RENESAS TECHNICAL UPDATE

Product Category	MPU & MCU	Document No.	TN-SH7-A604A/E	Rev.	1.00
Title	SDRAM Initialization Sequence Setting Procedure for SH7261/SH7201 Products		Information Category	Technical Notification	
Applicable Products	SH7261/SH7201 products	Lot No.	Reference Document	SH7261 Group Hardware Manual Rev.1.00 REJ09B0320-0100	
		All lots		SH7201 Group Hardware Manual Rev.1.00 REJ09B0321-0100

Figure 9.24 SDRAMC Setting Procedure (page 266 for SH7261 and page 262 for SH7201)

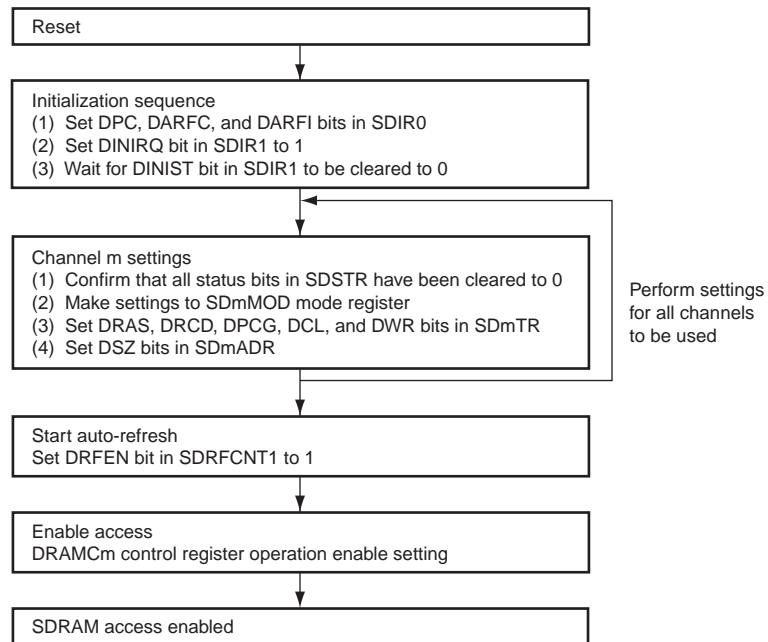
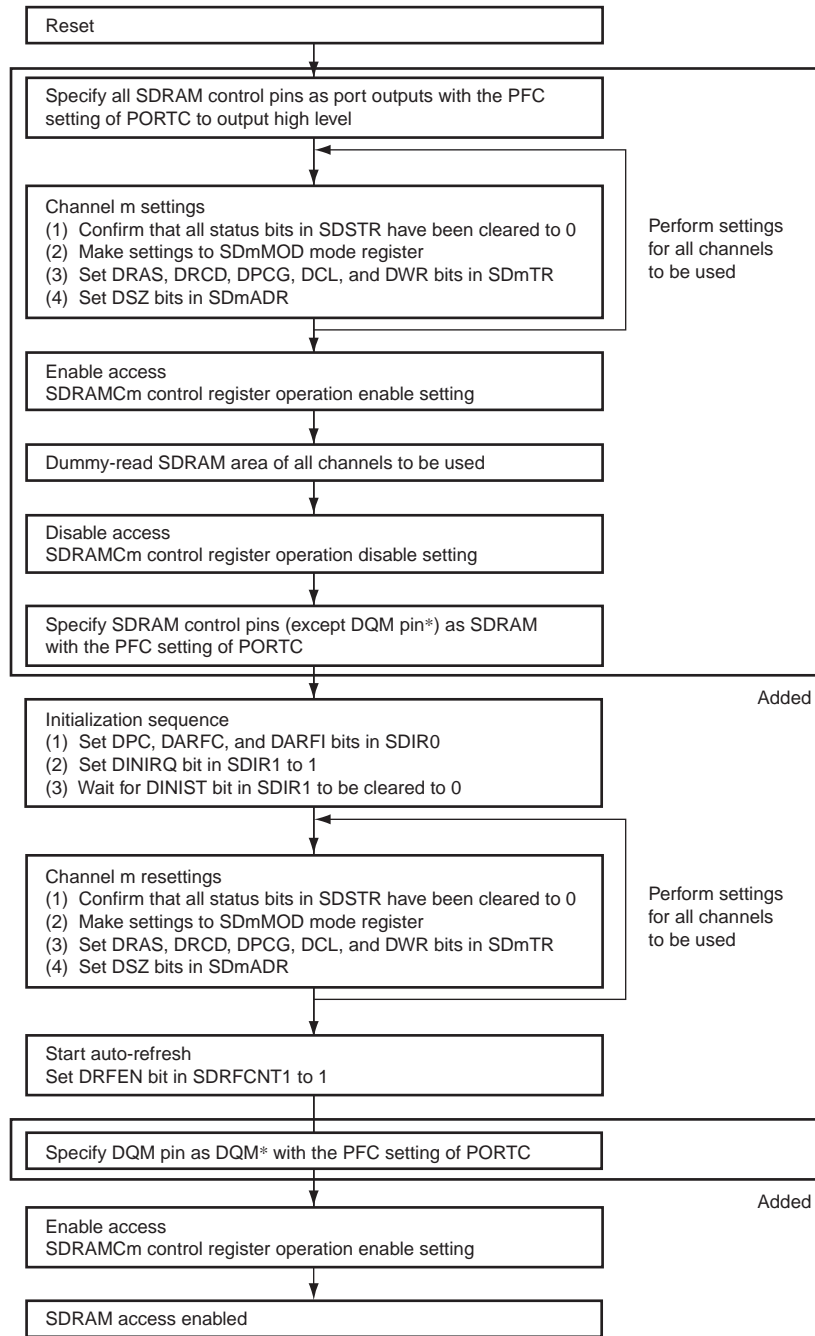
We would like to inform you of the discrepancy found between the specification of the SDRAM initialization sequence described in the SH7261 Group Hardware Manual (Rev. 1.0) and SH7201 Group Hardware Manual (Rev. 1.0) and the operation of this LSI.

The SH7261 Group and SH 7201 Group products include the initialization sequencer function for initializing SDRAM. The initialization sequence is performed after a reset or after a recovery from deep-power-down mode. The initialization sequence after a reset is performed in accordance with the procedure in figure 9.24 in (a) SDRAMC Setting Procedure in (12) SDRAMC Setting Examples in section 9.5.2, SDRAM Interface. In the initialization sequence performed after a reset, the discrepancy between the specification and the operation of this LSI was found. In the initialization sequence, the precharge-all-banks command (PRA) is issued for SDRAM according to the specification. However, when operating this LSI in accordance with the procedure in figure 9.24, the precharge-select-banks command (PRE) is issued (bank 0 is selected at this time). Although a high level must be output from the A12 pin to issue the PRA, a low level is output. This causes the PRE to be issued.

The SDRAM setting procedure is described as below to issue the PRA appropriately in the initialization sequence after a reset.

Note: * It is recommended that the DQM pin be driven high before the initialization sequence for some SDRAM. In this case, the setting may be necessary.

The PRA can be issued in the initialization sequence after a reset as described in the specification by following the above setting procedure.

In addition, it is recommended that the DQM pin be driven high before the initialization sequence for some SDRAM. The setting to support this is added to this SDRAM setting procedure.
